**WATER SUPPLY IMPROVEMENT PROJECT  
FINAL ENVIRONMENTAL IMPACT REPORT**

## **Environmental Impact Report for the Indian Wells Valley Water District Water Supply Improvement Project**

## Draft Environmental Impact Report for the Indian Wells Valley Water District Water Supply Improvement Project

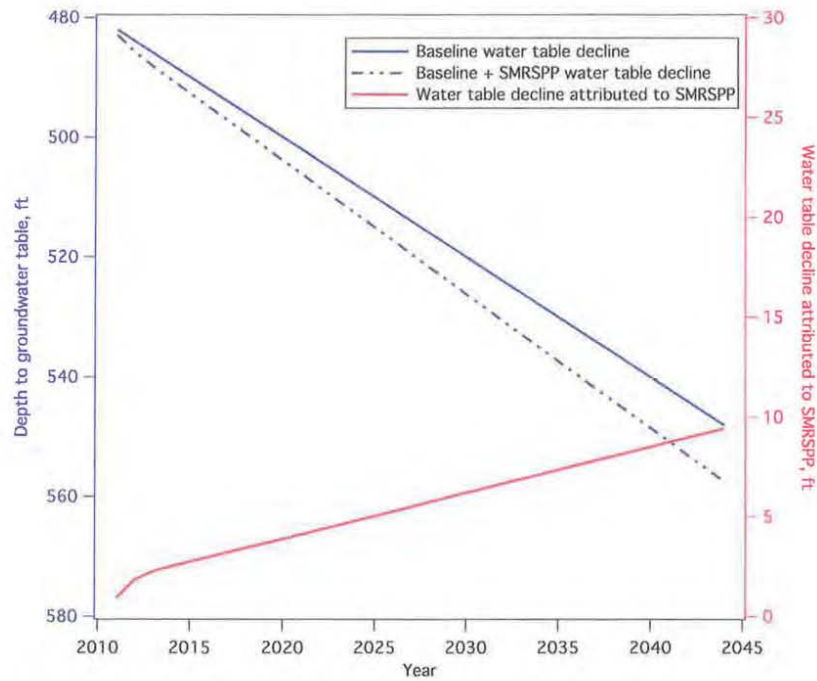
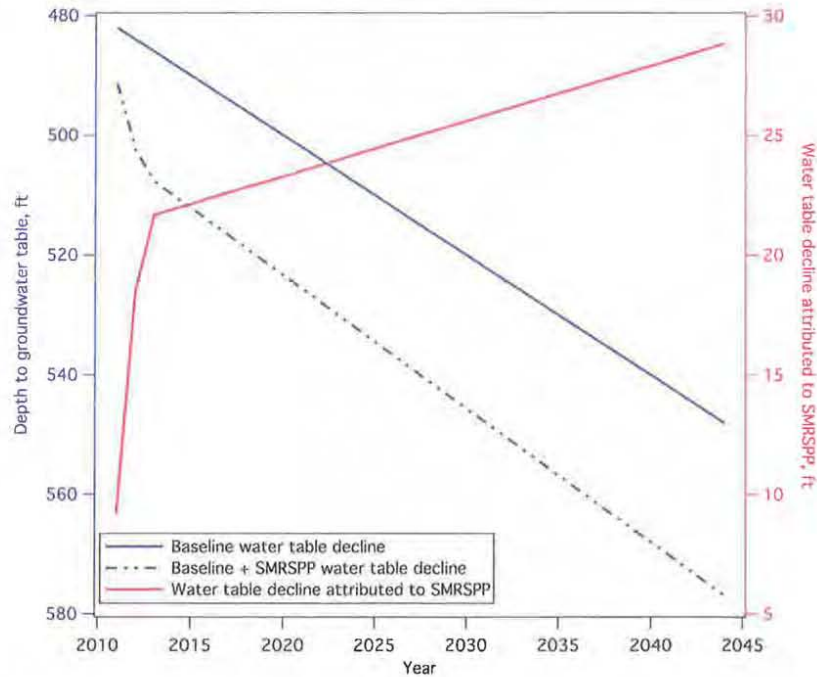
This calculation process was ported into a spreadsheet that in turn was used to compute the cumulative impact of water withdrawal from construction and subsequent operation of the plant. The results of this spreadsheet calculation are shown in the following figures. Using SM's estimate of 1,500 af total construction water, 170 afy for construction workers for 28 months, and 204.4 afy for operations and plant workers, the total cumulative construction and operational water table decline is over 9-feet after 30-years, shown as the red line attached to the right axis in Figure 1.

Now at the other end of the construction water use estimate is the 8,000 afy estimated by CEC staff<sup>4</sup> that results in a very significant amount of water lost to the existing water users of the IWV with a total water table decline of almost 29-feet as shown in Figure 2.

The separation between the baseline water table drop and the SM project water table drop curves is a result of the large initial water extraction and consumption to support construction of the plant. The change in slope between the two projections is the additional water needed to support plant operations and the 85 plant workers. The two effects combined result in an obvious, quantifiable impact of many feet of permanent (and irreversible with the present lack of imported water to the IWV hydrographic basin) water table decline which is shown as the red line in both figures.

Using this simple and straightforward first principles calculation method, the SM impact to IWV groundwater table decline will be between 9 and 30 feet after 30-years of plant operation depending on which construction water estimate one believes. As a civil engineer, I intuit that the construction water needs may well *exceed* 8,000 afy.

**Response to Comment 33-4:** This comment provides an alternative calculation for water level declines for the Proposed Project. Specifically, the commentor states that his evaluation, using an alternative hydrologic calculation method as opposed to the existing groundwater flow model, indicates that pumping an additional 8,000 acre-feet per year from the Southwest Well Field would result in an additional 29 feet of drawdown near the pumping well after 30 years. Pumping an additional 8,000 acre-feet per year from the Southwest Well Field is equivalent to doubling the current production of the IWWVD. Phase 2 of the Proposed Project is intended to meet a projected increase in demand of approximately one percent per year, or about 80 acre-feet per year. The technical assessment and modeling results developed for the CEQA analysis indicate that the rate of water level decline within one-half mile of new well 35 will increase by approximately 0.5 feet per year above the baseline rate. Thus, over 30 years, the Proposed Project would result in an additional 15 feet or drawdown within one-half mile of the pumping well. This additional drawdown is about half of that estimated by the commentor for an annual extraction volume that is 100 times greater than that which would occur under the Project. Based on the information provided by the commentor, the groundwater model used for the EIR analysis would appear to over-estimate the drawdown that may result from Phase 2 of the Proposed Project.
